DATE: September 16, 2026

TO: Prospective Bidders

SUBJECT: Addendum No. 2 to the Bidding Documents for:

Mehlville School District – Bus Transportation Facility Project

FLOOR PLANS

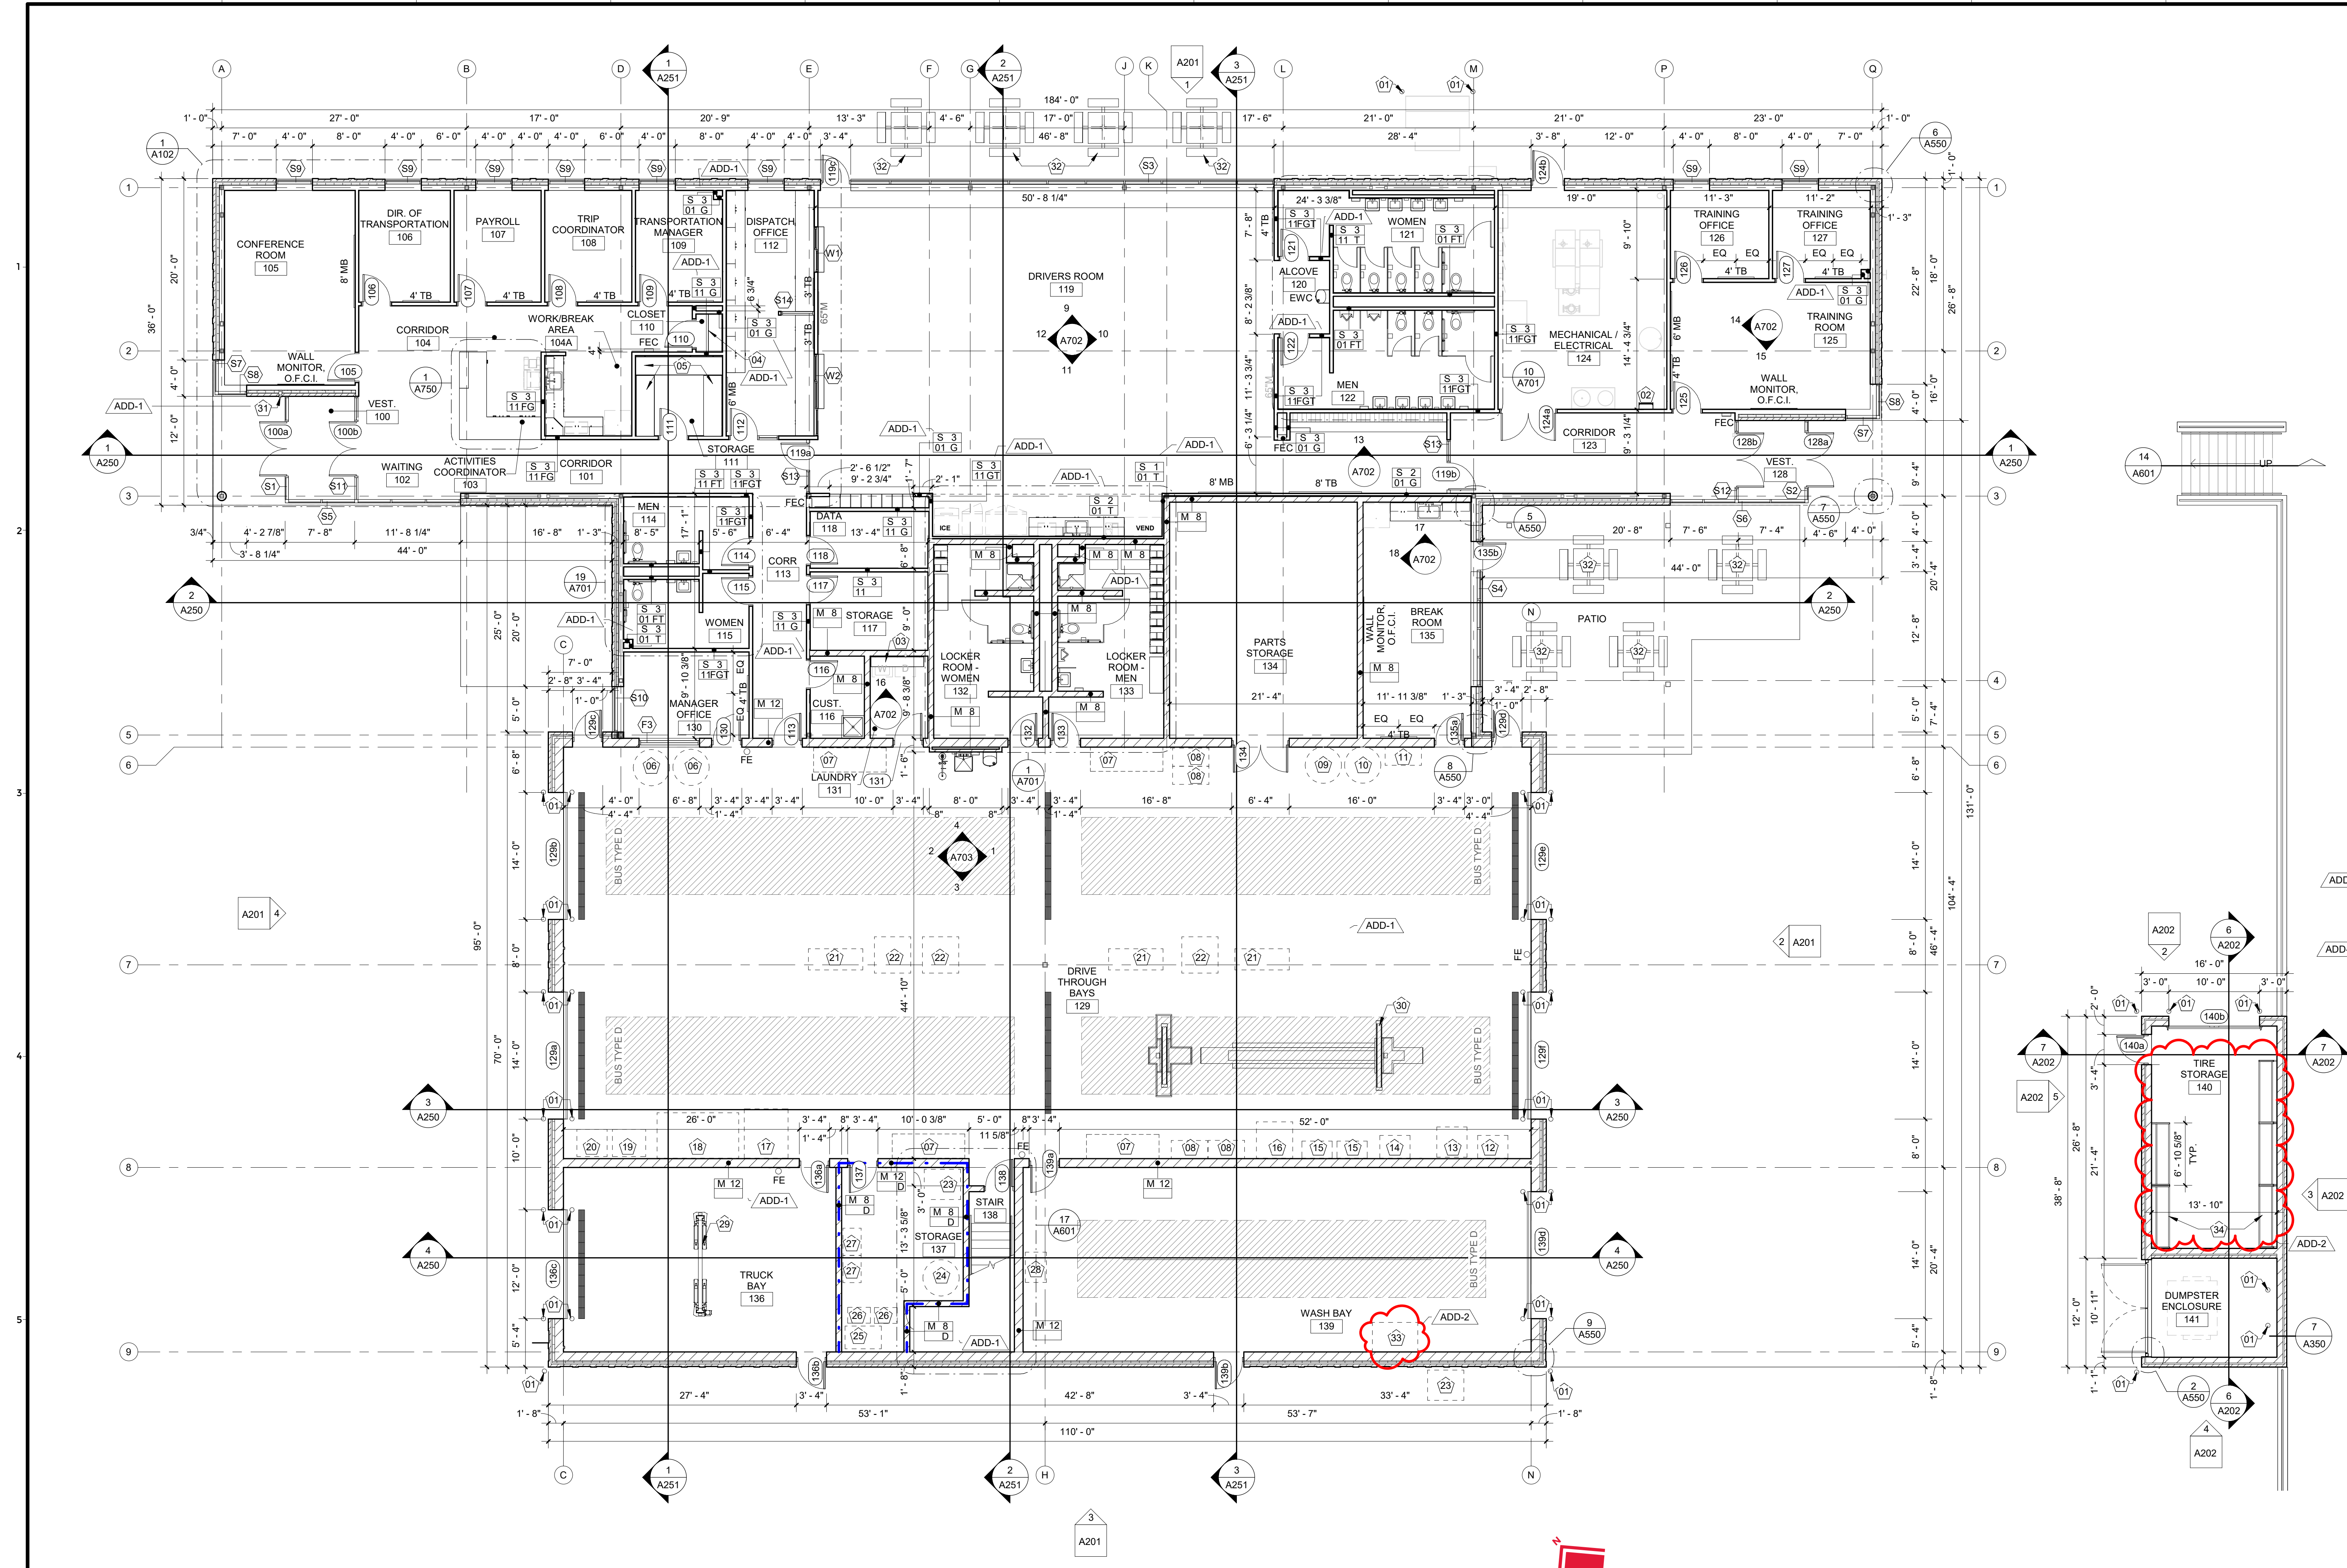
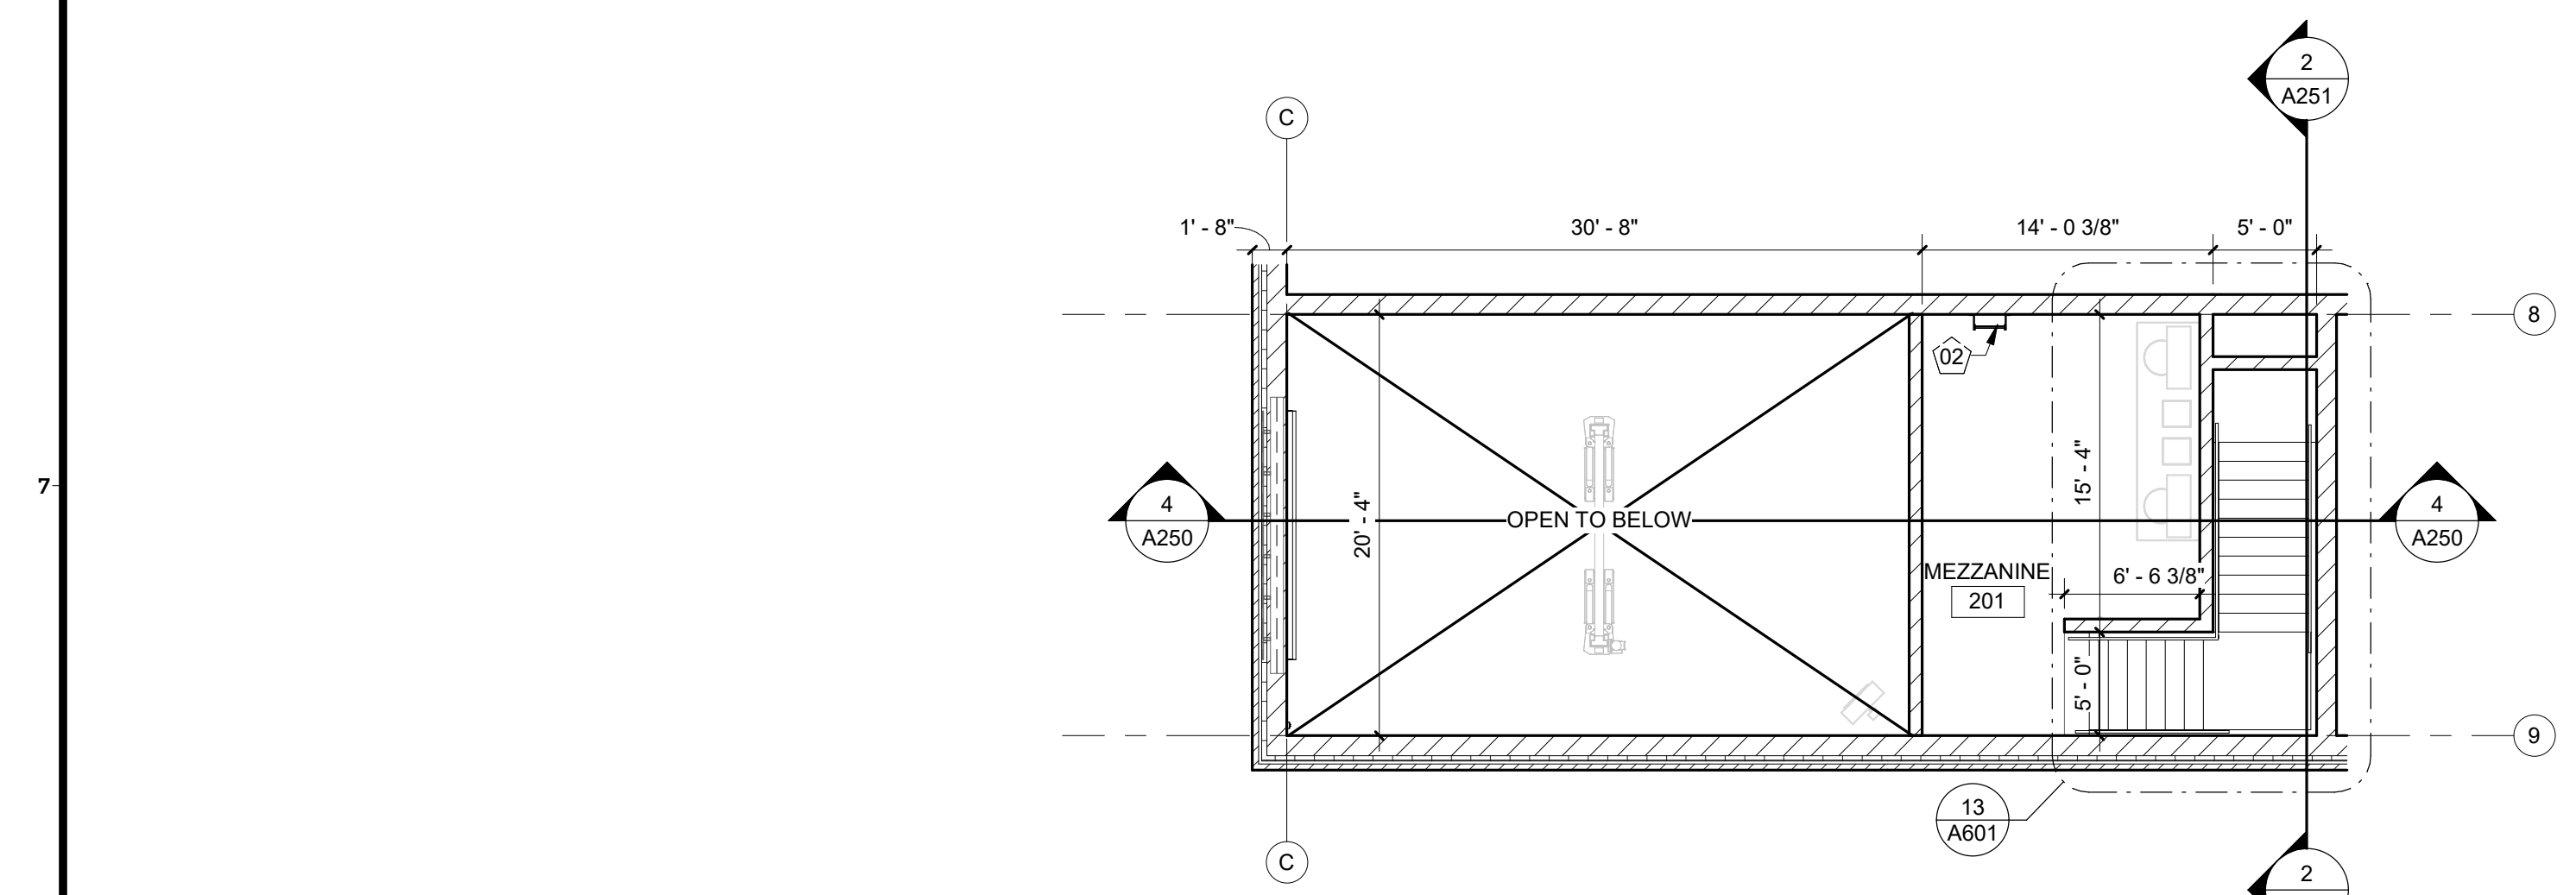
- a. **REVISE** tire racks in Tire Storage 140.
- b. **ADD** Floor Plan Keynote 34.
